From: Jim Smith
To: Austin Belcher; OGMCOAL
CC: Karl Houskeeper
Date: 5/13/2009 11:05 AM
Subject: 2nd Quarter 2008 Water Quality Memorandum
Place: OGMCOAL
Attachments: final_jdsWQ08-02.doc

WATER QUALITY MEMORANDUM
Utah Coal Regulatory Program

RE: 2008 Second Quarter Water Monitoring, Company, LLC, Mine, Permit & Tracking #

Chloride at CS-3

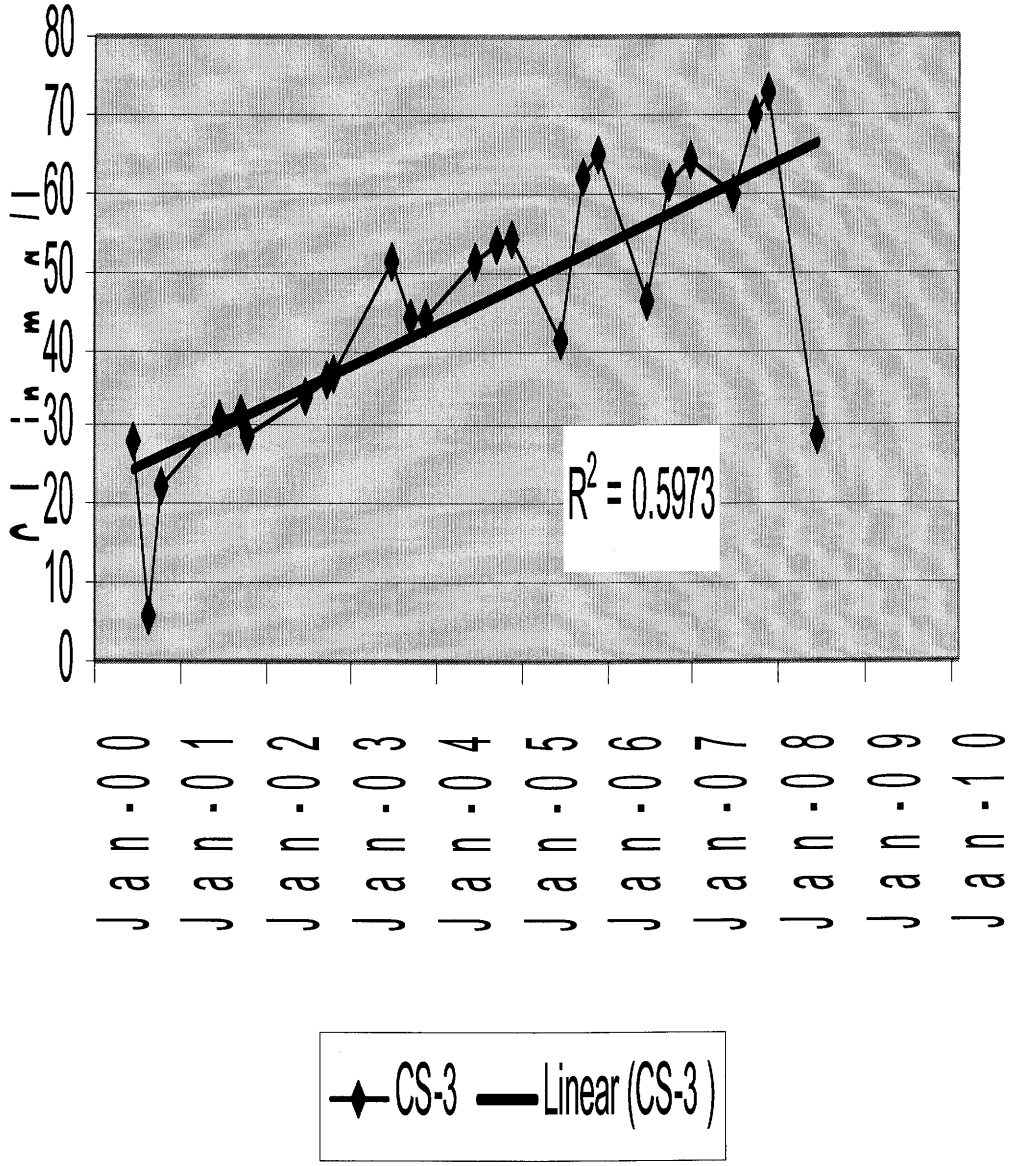
Up until the First Quarter 2008, chloride values were increasing steadily at CS-3; however, the value has dropped to 29 mg/L, well below the average of 44 mg/L and comparable to the values that were being obtained when monitoring at this point began in 2000. See the attached chart.

NO2 + NO3 in Streams
mg/L
6
5
4
3
2
1
0
Jan-00
Jan-01
Jan-02
Jan-03
Jan-04
Jan-05
Jan-06
Jan-07
Jan-08
Jan-09
Jan-10
CS-3
CS-9
CS-11
VC-9

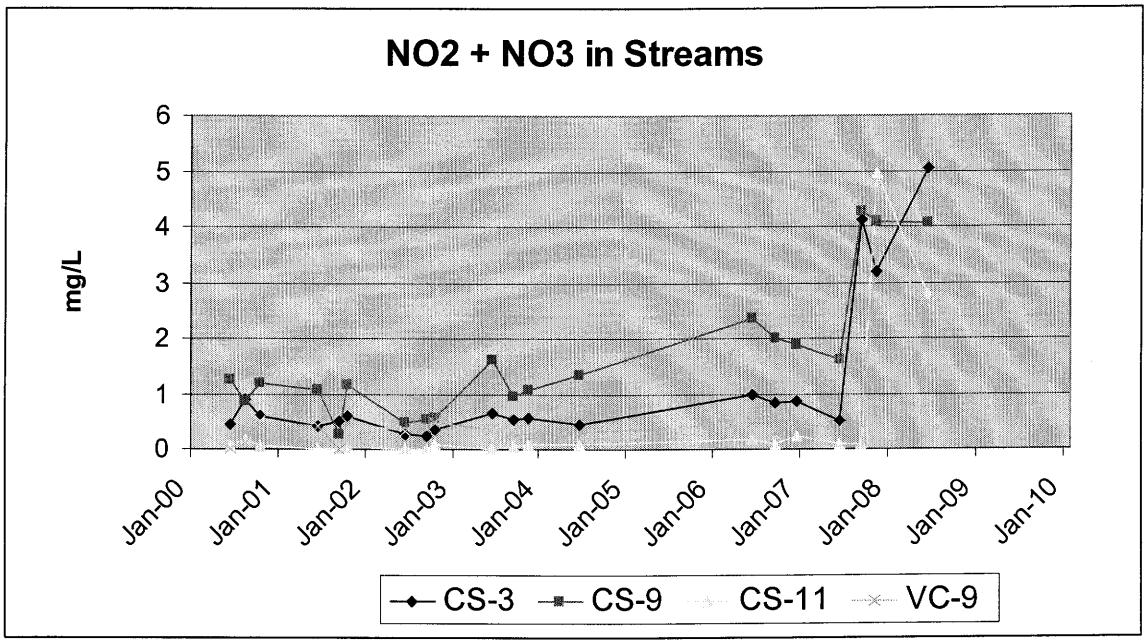
Ten sites had elevated NO2+NO3 as N: five stream sites and five springs. See the attached charts. There is no evident explanation for such a large number of sites with elevated N values. This parameter will be checked in successive quarters to determine if there is a trend or pattern.
